February 3, 1978

Docket Nos. 50-2
50-247
and 50-286

The Commission has issued the enclosed Amendment No. 18 to Provisional Operating License No. DPR-5, Amendment No. 37 to Facility Operating License No. DPR-26 and Amendment No. 11 to Facility Operating License No. DPR-64 for the Indian Point Nuclear Generating Units Nos. 1, 2 and 3, respectively. These amendments consist of changes to the Technical Specifications for each license in partial response to your applications transmitted by letters dated November 2, 1977. As discussed with your staff, modifications have been made to your proposed changes to meet regulatory requirements.

These amendments revise the Technical Specifications to change requirements for administrative controls. The other changes you requested for Units 2 and 3 in your November 2, 1977 letters will be handled by separate licensing actions.

Figure 6.2-1 Facility Management and Technical Support Organization

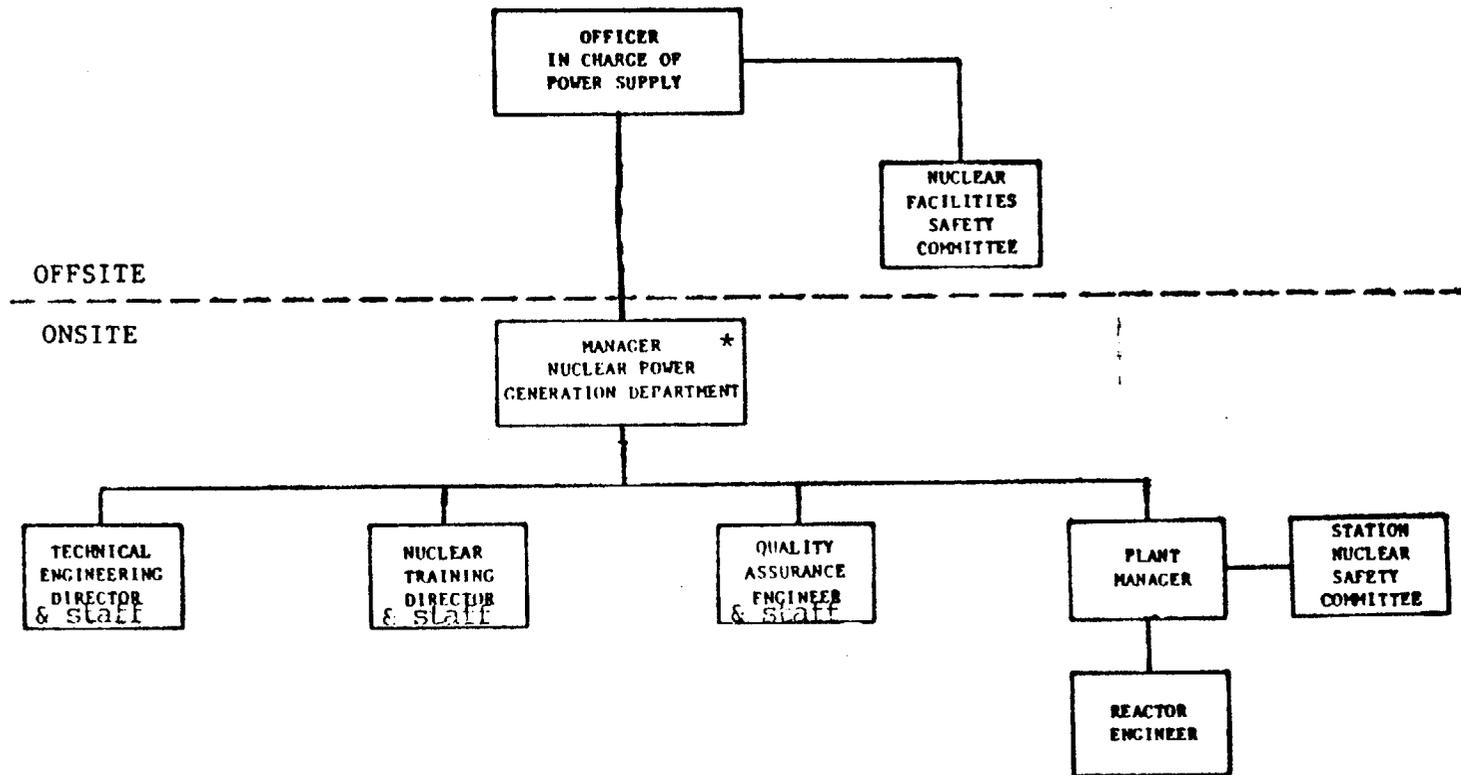
1. Change Technical Specifications to clarify Nuclear Facilities Safety Committee responsibilities;
2. Change organizational chart to reflect current organizational responsibilities to show that the Manager-Nuclear Power Generation Department would report directly to the Officer In Charge of Power Supply; and
3. For Units 2 and 3 add the Refueling Engineer as a member of the Station Nuclear Safety Committee.
